LEVEL 2 REMODEL
SECTORS 5A, 5B & 6
COLLEGE COMPLEX
LOS MEDANOS COLLEGE
2700 EAST LELAND DRIVE
PITTSBURG, CA 94565

REQUEST FOR INFORMATION

RFI # 143

HVAC Ductwork in Restrooms 230 & 231

Drawing M1.0 Published

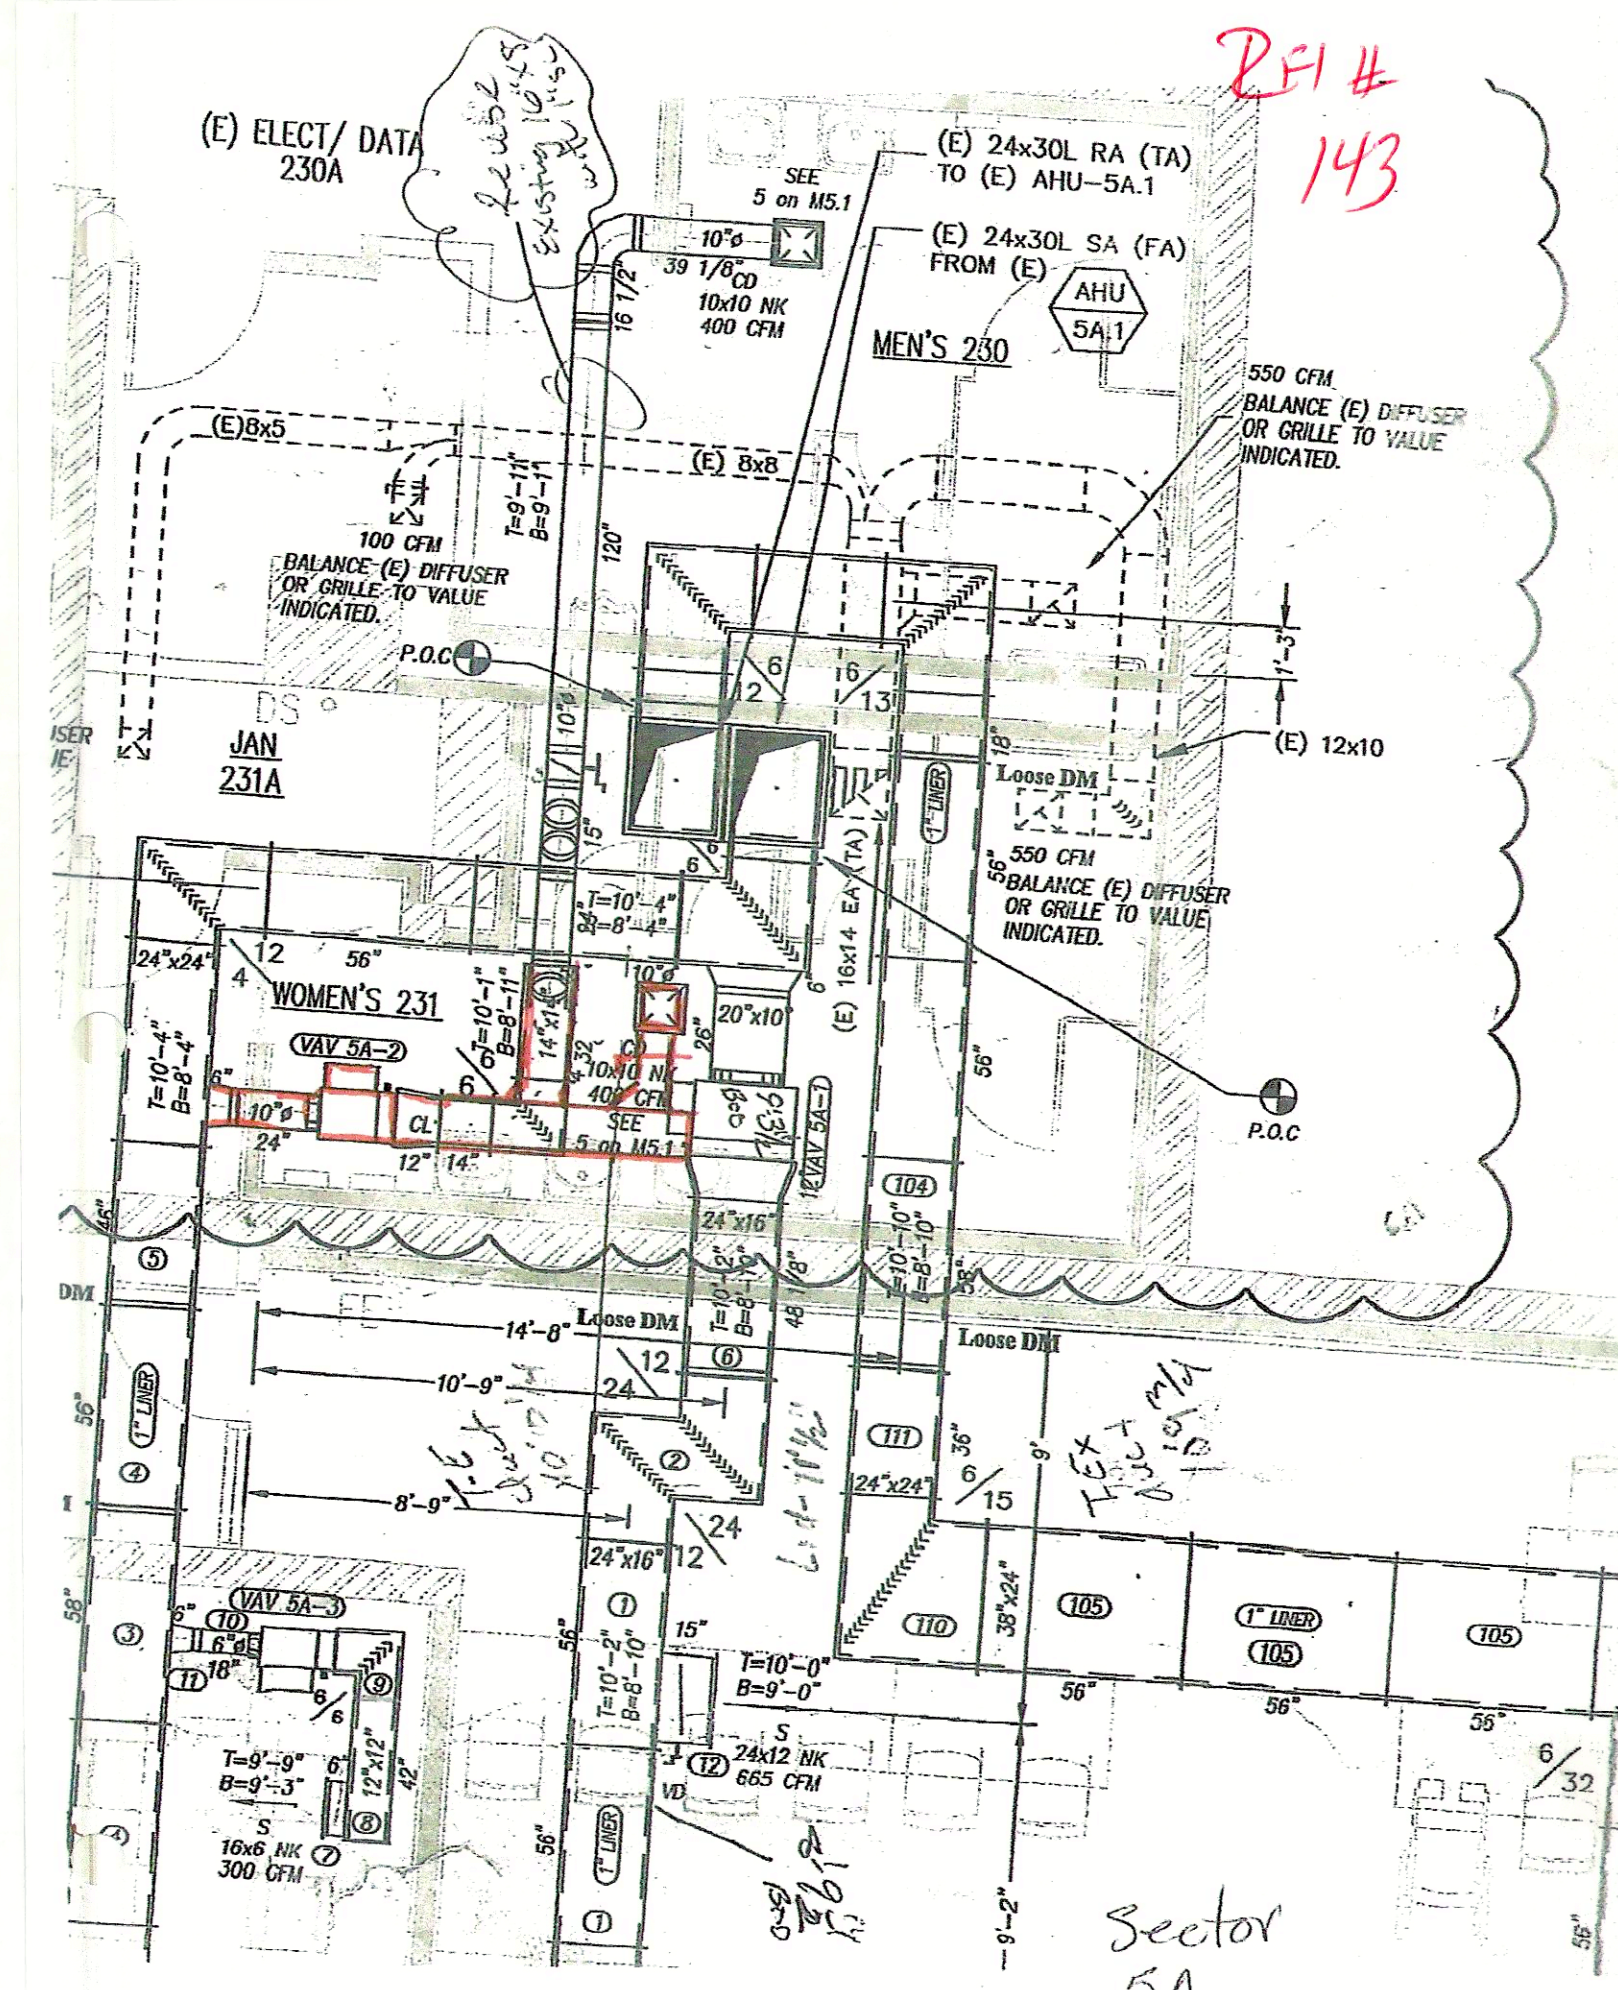
COMMENTS: Do to existing conditions could we relocate the ductwork as noted in red and reuse the exiting 10" ductwork to the men's restroom?

Reference is made to the attached Martinez Sheet Metal RFI dated 7/25/2017. Can the ductwork shown in red be relocated and the 10" existing ductwork to the men's restroom be reused?

We do not take exception to the coordinated duct location and reuse of existing ductwork proposed by the contractor.

drawing title:
HVAC DEMO FLOOR PLAN
drawing no:
M1.0
drawing of

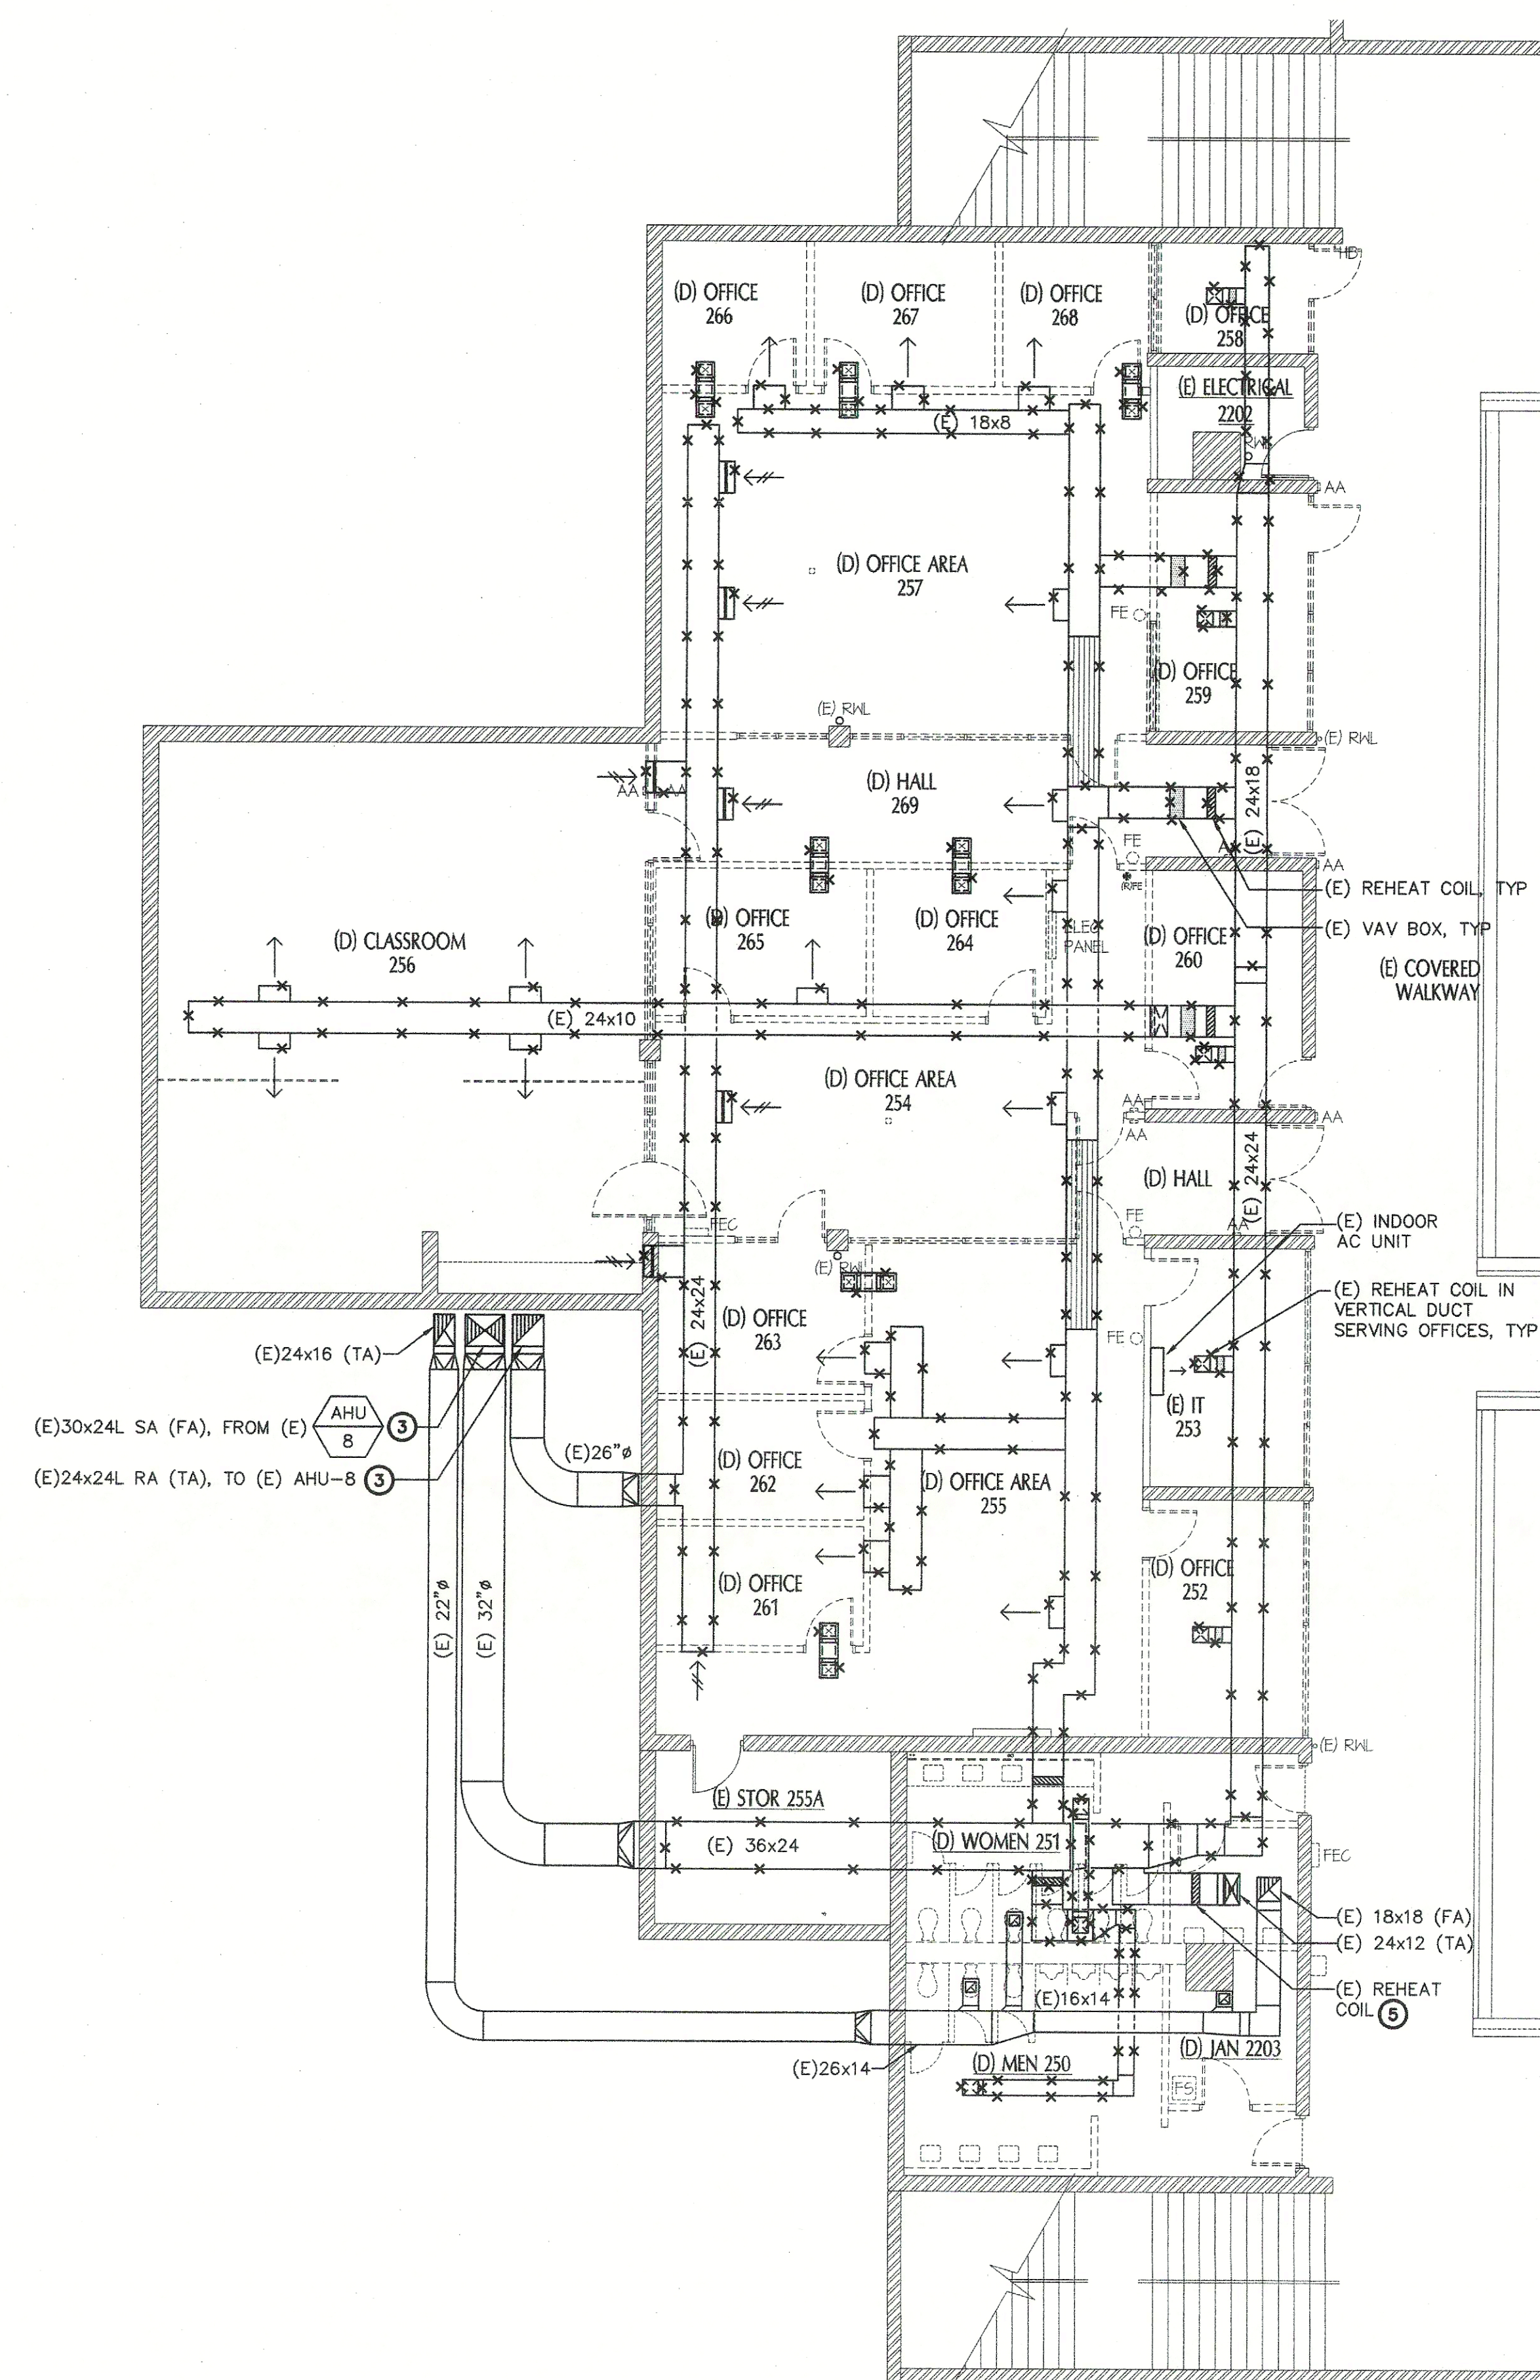
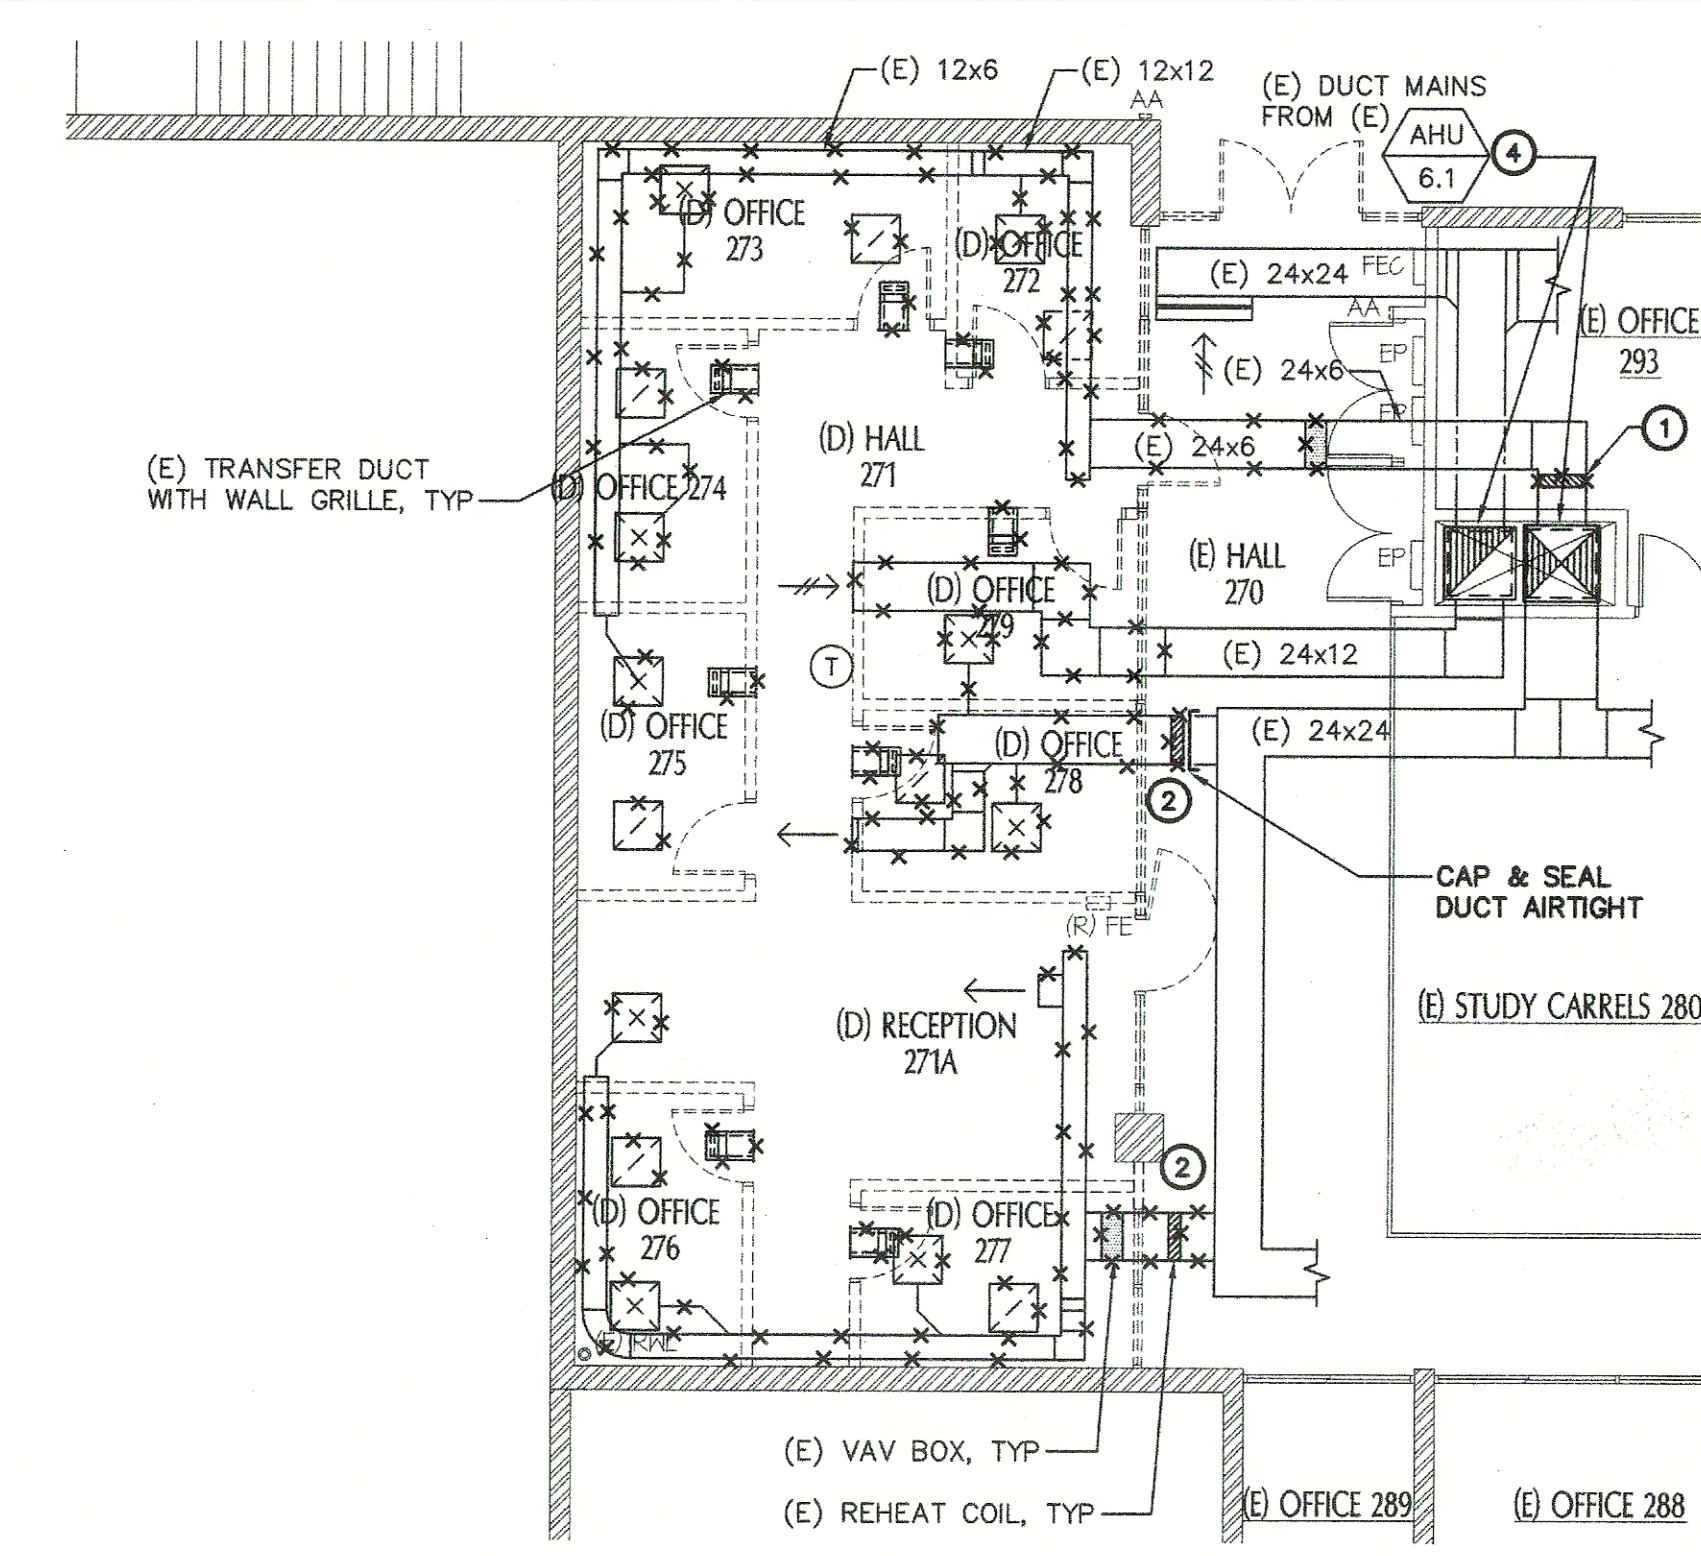
REF #143
Relocate
duct work in
Rm 200 / Re-use AHU 101
in main row
